State of West Virginia  
 Department of Administration  
 Purchasing Division  
 2019 Washington Street East  
 Post Office Box 50130  
 Charleston, WV 25305-0130

NUMBER
GSD136417

Addendum Number: 2

To add a copy of the mandatory pre-bid attendee list, to answer all technical questions submitted in accordance with the provisions of the original solicitation and all issued addenda, and to extend the bid opening date. Bid opening date is extended to 06/26/2013 at 1:30 PM EST.

CAISSON & ESTIMATED BEDROCK ELEVATION PLAN

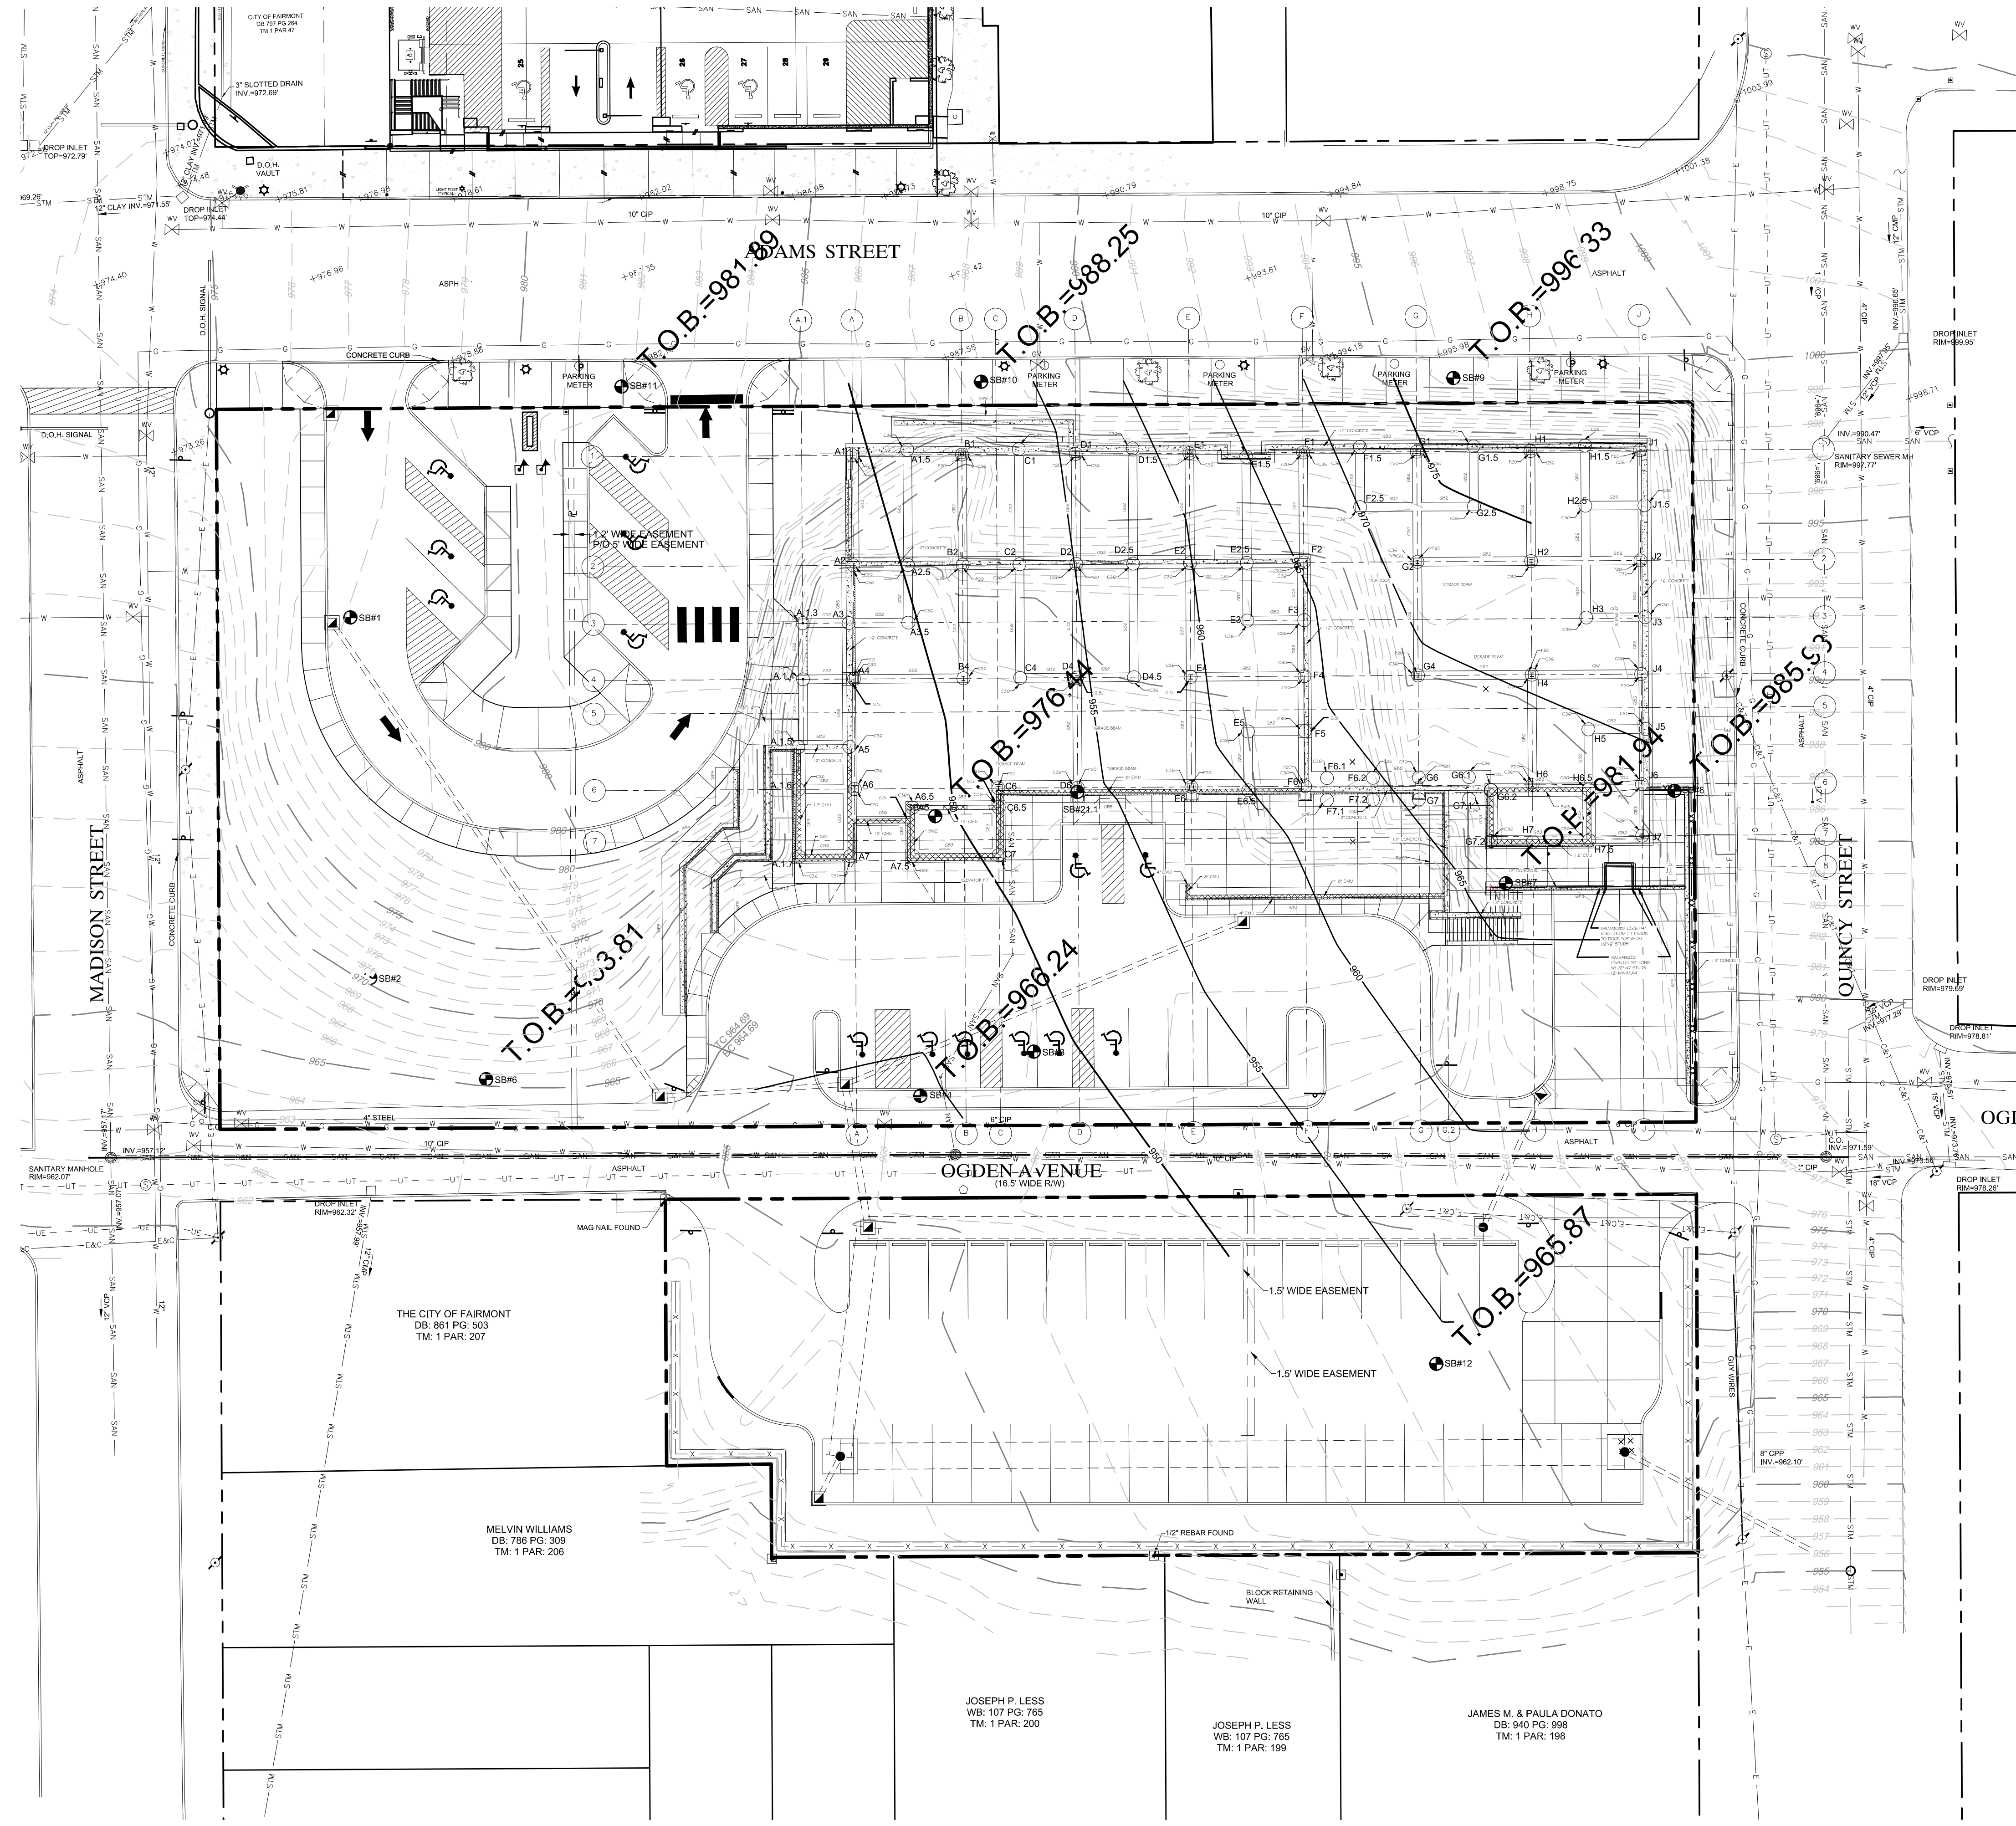
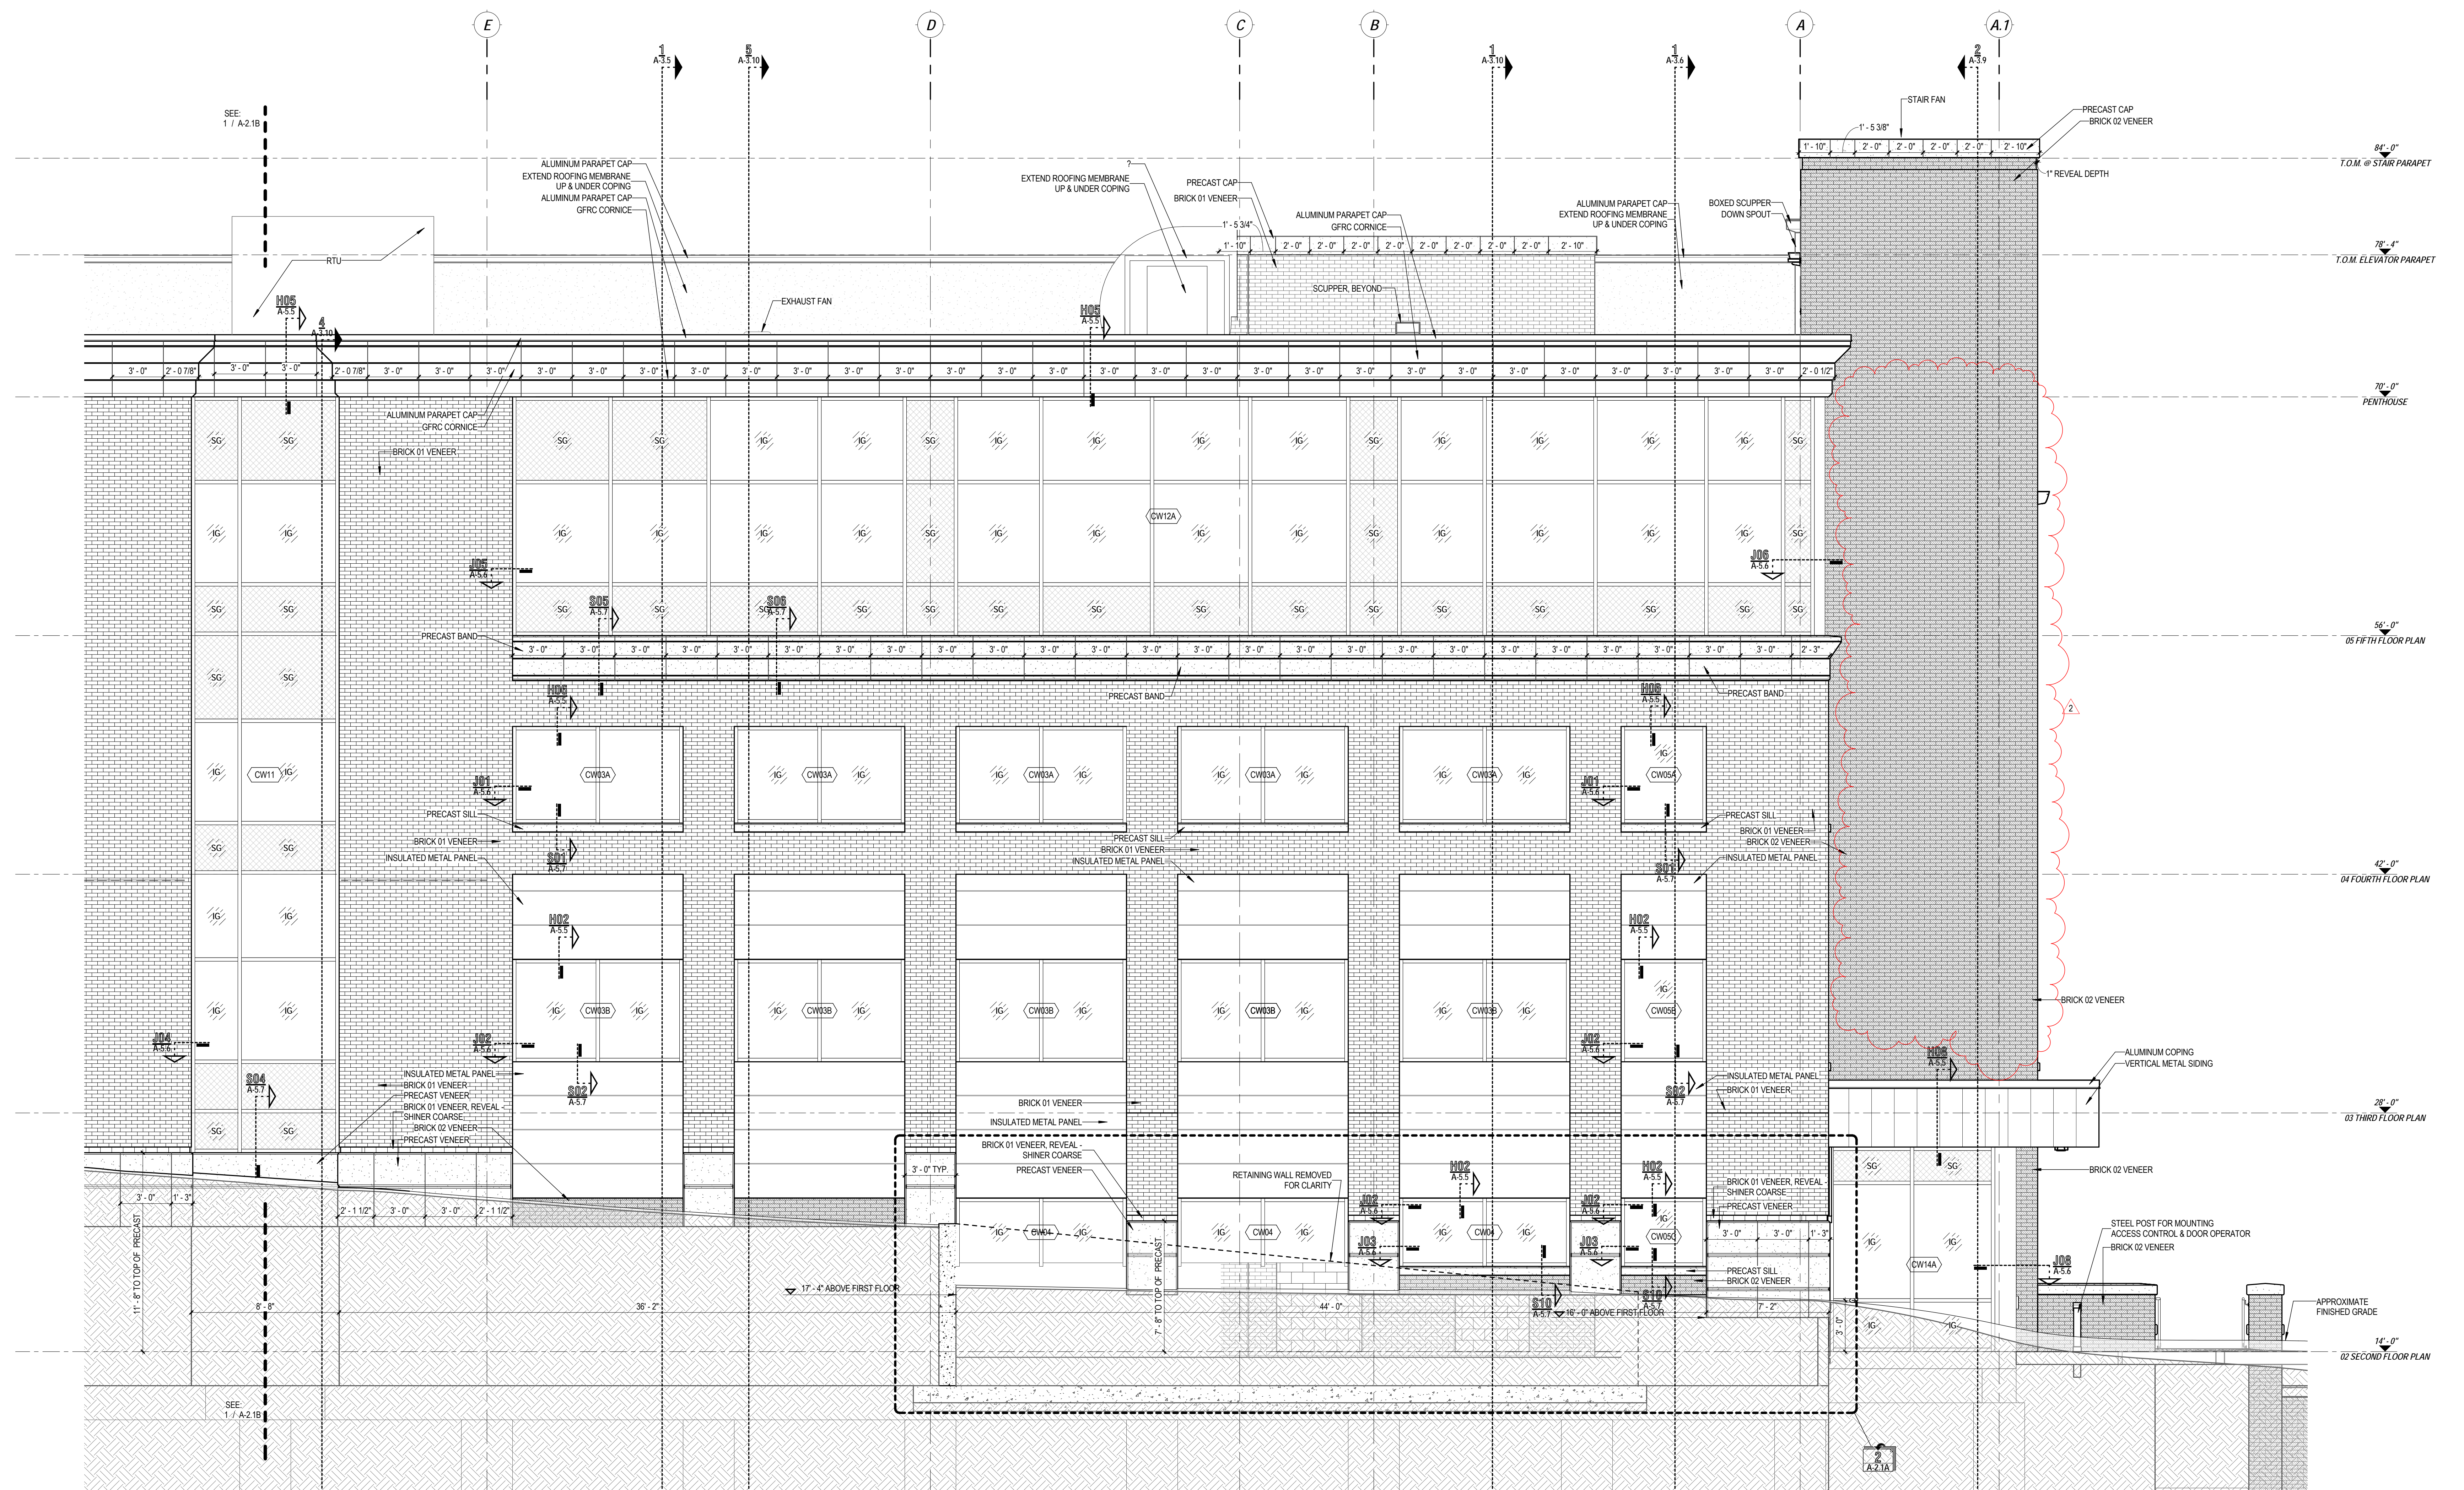
**Addendum 2 – ITEM 10, SHEET C-8 CAISSON AND ESTIMATED BEDROCK ELEVATION PLAN**

- A. ADD this sheet in its entirety per **Attachment U**. This sheet provides the following information pertaining to bedrock elevations and caisson depths at the site.
  - a. Location of Soil Borings at the site which encountered bedrock.
  - b. Estimated bedrock surface elevation contours based upon soil borings.
  - c. Table providing boring numbers, surface elevations, depth to rock and top of bedrock elevations.
  - d. Caisson listing with estimated bedrock elevation at each caisson location.
  - e. In addition to the depth to bedrock at each caisson location add the socket depth into rock in order to calculate the estimated total depth of each caisson.
